# Work Order ID 118408

Item Name: Aft Crosstube - High 407

Reference: NCR - RLC

DRAWING NO. D407-667-245	TITLE CROSSTUBE ASSY (407 HIGH AFT)	REV. F	DART AEROSPACE LTD ENGINEERING ORDER		D.E.O. NO. D407-667-245-F-1	SHEET NO. SHEET 1 OF 2	SCALE NTS
DRAWN <i>[Signature]</i>	CHECKED <i>[Signature]</i>	MFG. APPR. <i>[Signature]</i>	APPROVED <i>[Signature]</i>		DE APPR. <i>[Signature]</i>		
DATE 11.04.08	DATE 11.04.12	DATE 11.04.12	DATE 11.04.12		DATE 11.04.12

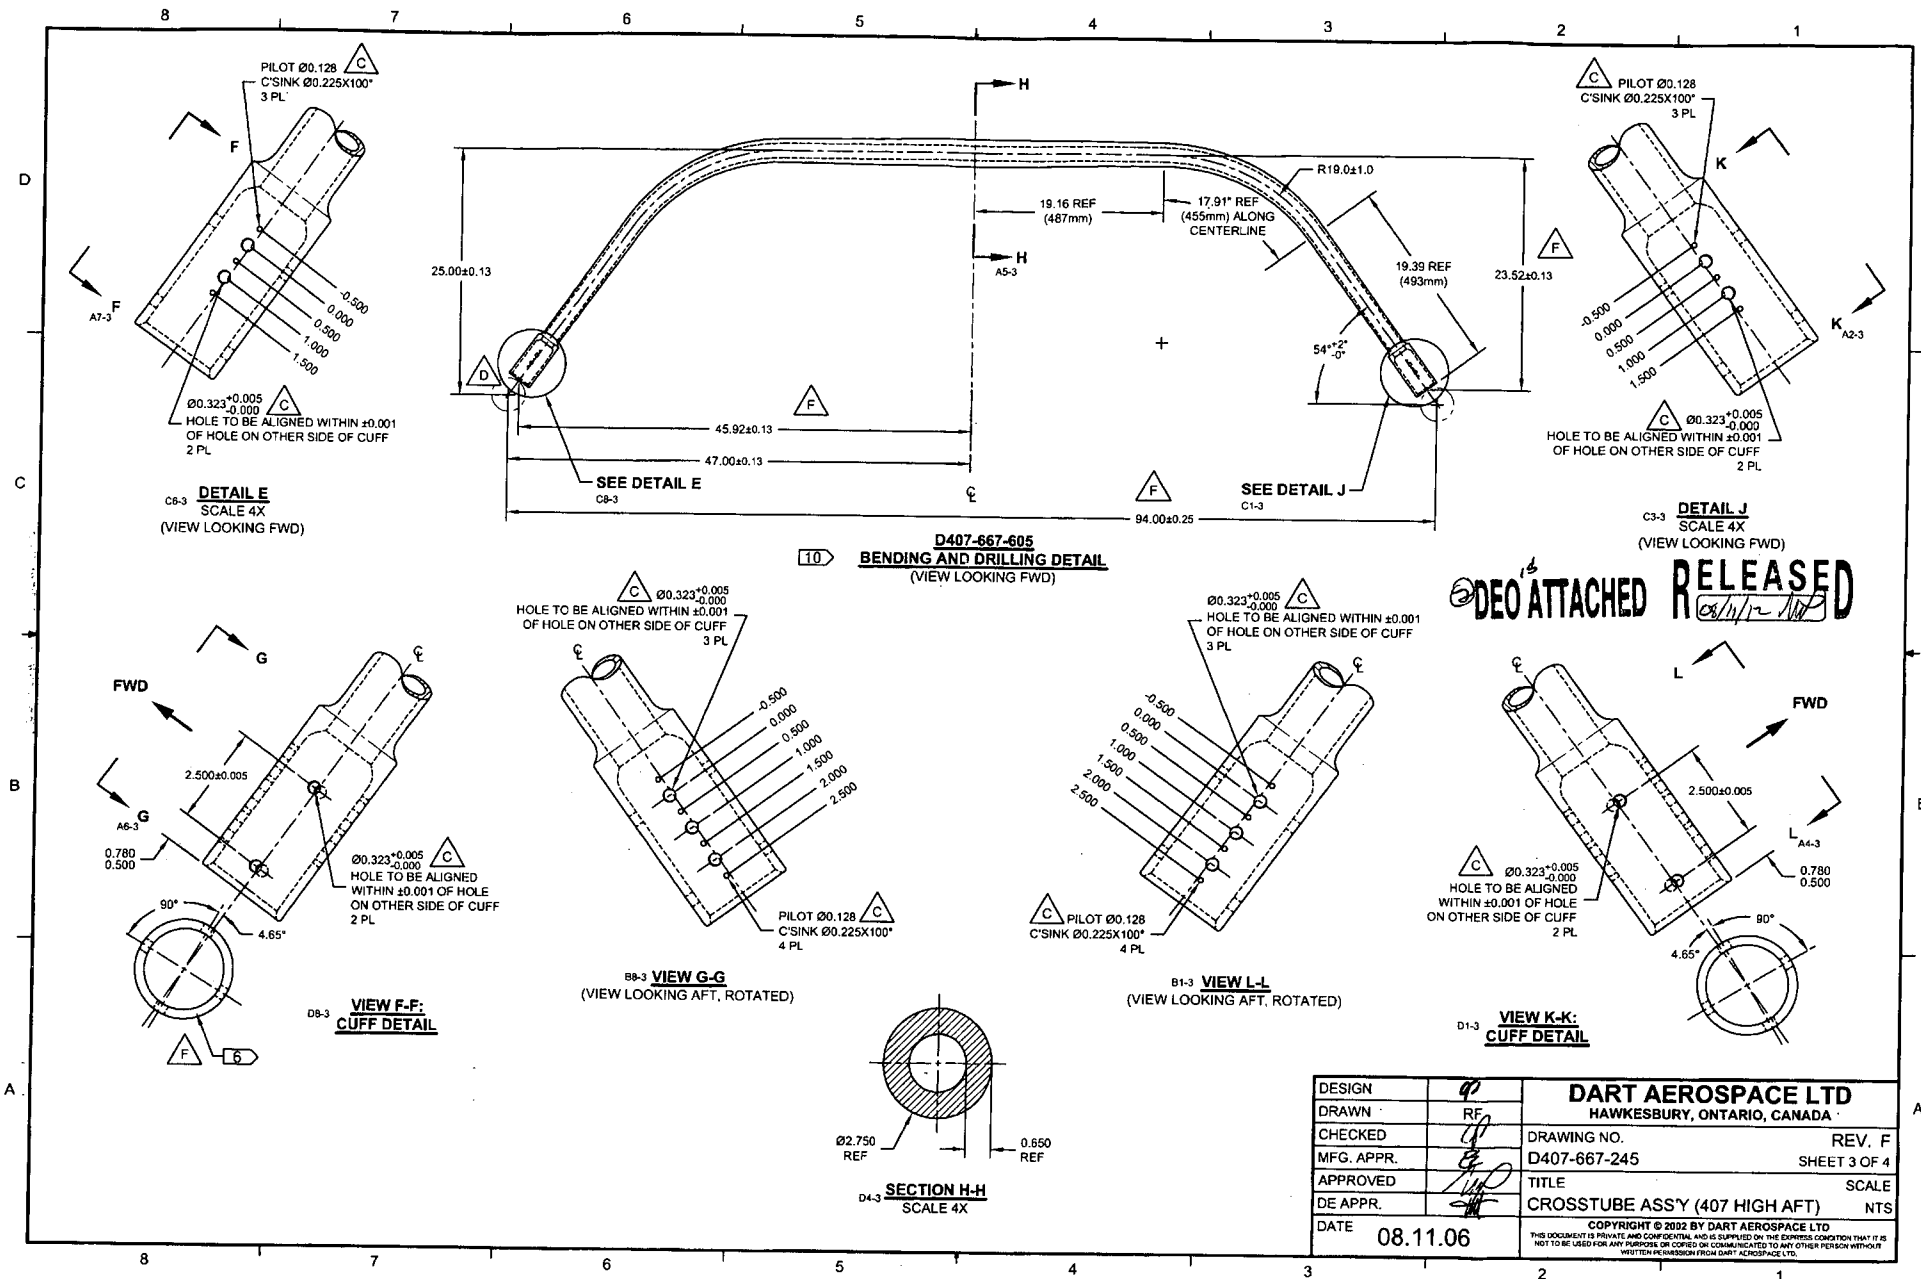
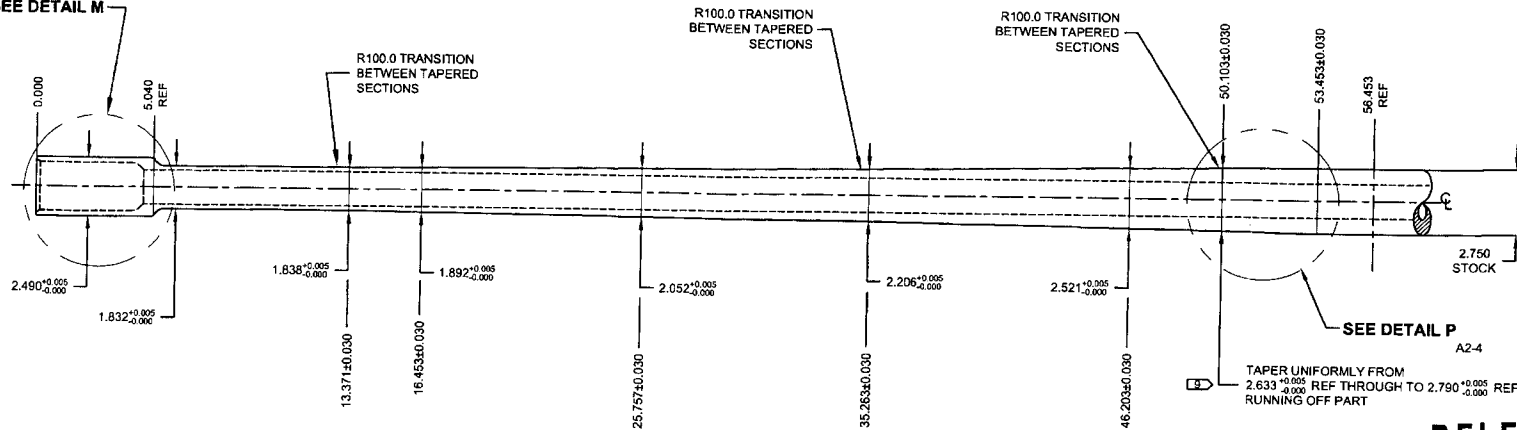
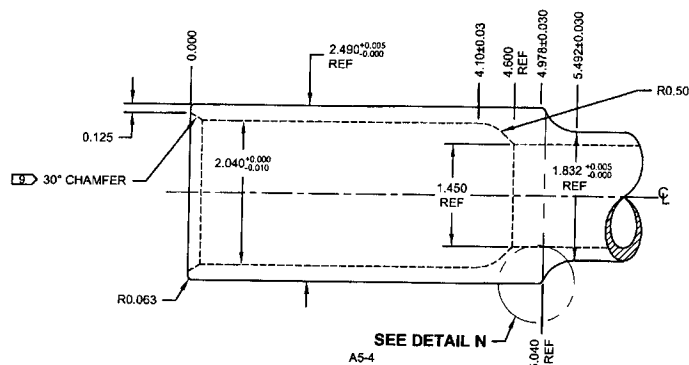
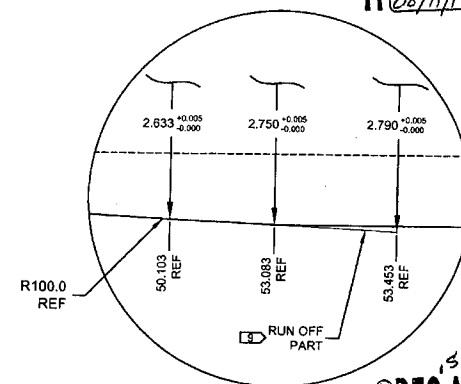
F	REFORMAT NOTES TO NEW STANDARDS (ZN B8-1); RELOCATED FLAG # 6 (ZN AB-3) PER NCR 210; REMOVED REF. & ADD TOLERANCES (ZN C6-3, C4-3 & D2-3)	RF	08.11.06
E	8.02 AND 8.53 WERE 8.40 AND 8.90 (ZN D5-2); REORGANIZED VIEWS AND REFORMATED DRAWING TO CURRENT STANDARDS. REASONS: CLAMPS MOVED 0.375 TOWARD CL TO ELIMINATE INTERFERENCE WITH AIRCRAFT MOUNTS. REFERENCE: FAR#08-21 AND ECN#1225	MB	08.07.24
D	ADD VIEW FOR OEM SKID HOLES, ROTATE ORIENTATION OF CLAMPS SECTION F-F, REMOVE -851 ABRASION STRIP, ADD MAGNOBOND 6398, ADD CUSHION	PH	07.02.07
C	ADD HOLES AND NUT PLATES FOR COMPATIBILITY WITH BHT/AA SKIDTUBES	PH	05.07.26
B	ADD CHAFING SHIELD	CP	03.05.21
A	NEW ISSUE	CP	02.05.13
REV.	DESCRIPTION	BY	DATE
DESIGN	RF	DART AEROSPACE LTD HAWKESBURY, ONTARIO, CANADA	
DRAWN	RF	DRAWING NO. D407-667-245	REV. F SHEET 1 OF 4
CHECKED	RF	TITLE CROSSTUBE ASS'Y (407 HIGH AFT)	SCALE NTS
MFG. APPR.	RF	COPYRIGHT © 2002 BY DART AEROSPACE LTD THIS DOCUMENT IS PRIVATE AND CONFIDENTIAL AND IS SUPPLIED ON THE EXPRESS CONDITION THAT IT IS NOT TO BE USED FOR ANY PURPOSES OR COPIED OR COMMUNICATED TO ANY OTHER PERSON WITHOUT WRITTEN PERMISSION FROM DART AEROSPACE LTD.

Please see attached photos we got from RLC. They are reporting issues with the position of the off-center supports on their D406-667-205 crosstube. As shown in attached photos, the supports are installed too far inboard: should be installed at 8.53" from center line while they are at 8.43"... This results in interference issue with the OEM clamps/supports.

Crosstubes PULL FROM STK:  
1 X D407-667-205 B116464  
REWORK - POSITION OF OPER CENTER SUPPORTS - INSTALL AT 8.53"  
FROM CENTERLINE

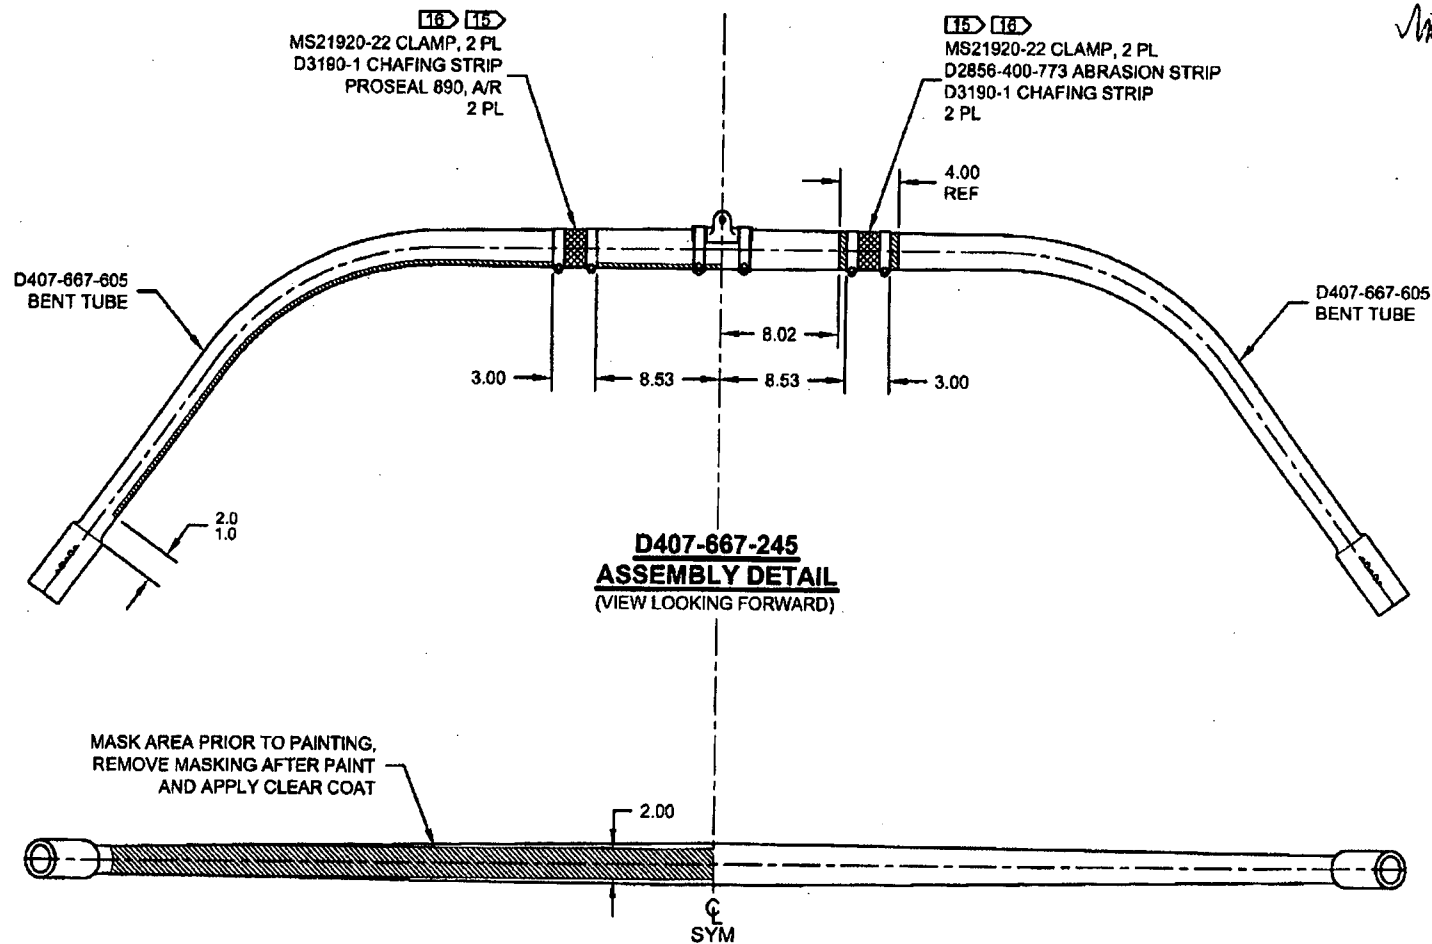
**PURPOSE:**

REMOVED ABRASION STRIP IN FAVOR OF A THIN LAYER OF PROSEAL 890.

NOTES 2 AND 15, SHEET 1 ARE AMENDED AS FOLLOWS:

- 2) FINISH: CHEMICAL CONVERSION COAT PER DART QSI 005 4.1  
PRIME INSIDE AND OUTSIDE PER DART QSI 005 4.2  
PAINT OUTSIDE PER DART QSI 005 4.2
- 15) INSTALL D2856-400-773 ABRASION STRIP WITH A 0.13 REF GAP ON BOTTOM SIDE OF  
CROSSTUBE PER QSI 035.

- 2) FINISH: CHEMICAL CONVERSION COAT PER DART QSI 005 4.1  
PRIME INSIDE AND OUTSIDE PER DART QSI 005 4.2  
MASK UNDERSIDE OF CROSSTUBE AS SHOWN (HATCHED AREA) AND  
PAINT OUTSIDE PER DART QSI 005 4.2  
REMOVE MASKING AND APPLY CLEAR COAT
- 15) APPLY A THIN COAT OF PROSEAL 890 ON INSIDE CONCAVE SURFACE OF D3190-1  
CHAFING SHIELDS AND LET CURE PER MANUFACTURER'S INSTRUCTIONS. INSTALL  
PROSEALED D3190-1 CHAFING SHIELDS ONTO CROSSTUBE BY APPLYING A THIN COAT  
OF PROSEAL 890 ONTO CROSSTUBE. BE SURE TO ELIMINATE ANY AIR GAPS.
